KAGRA Sensitivity for Observation Scenario Paper 2018

Yuta Michimura

Proposal for Update v20181005

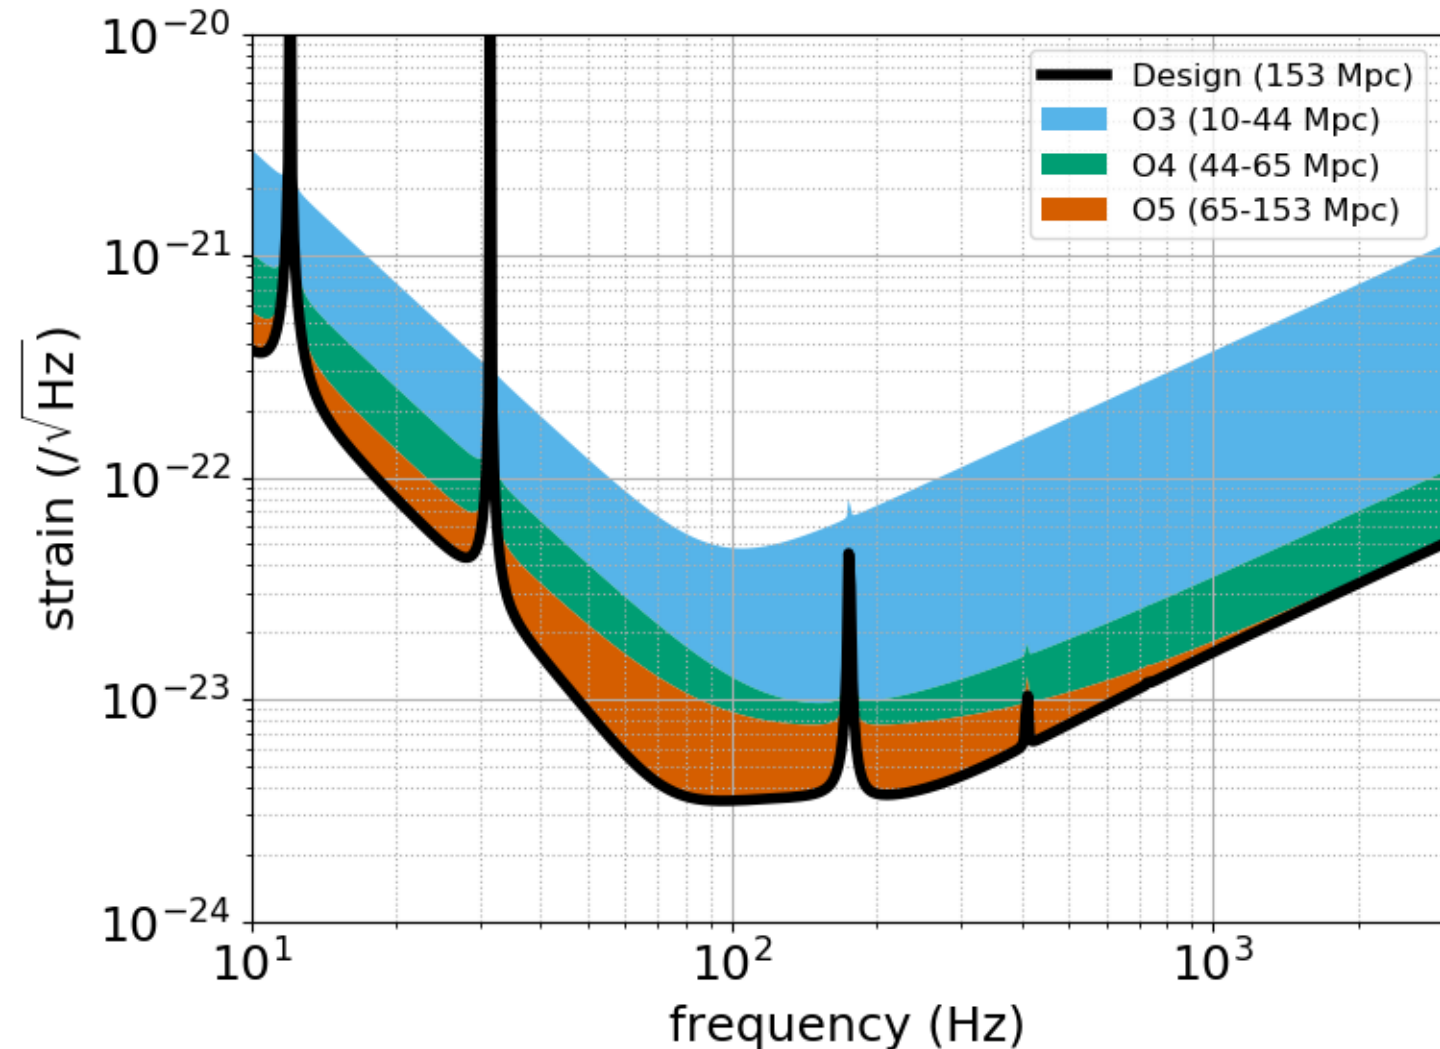
- 44 Mpc for O3 high sounds a bit too ambitious compared with 25 Mpc for Early high (2019.4-2020.3) in previous version
- People might think we should aim for the design sensitivity for O4
- DRSE in O4 might be too ambitious

- Reflect recent discussions on O3 sensitivity ([JGW-T1707556](#), [JGW-T1808172](#)) and latest estimated sensitivity ([JGW-T1707038](#))

O4-80Mpc as
“most probable”
O4 sensitivity
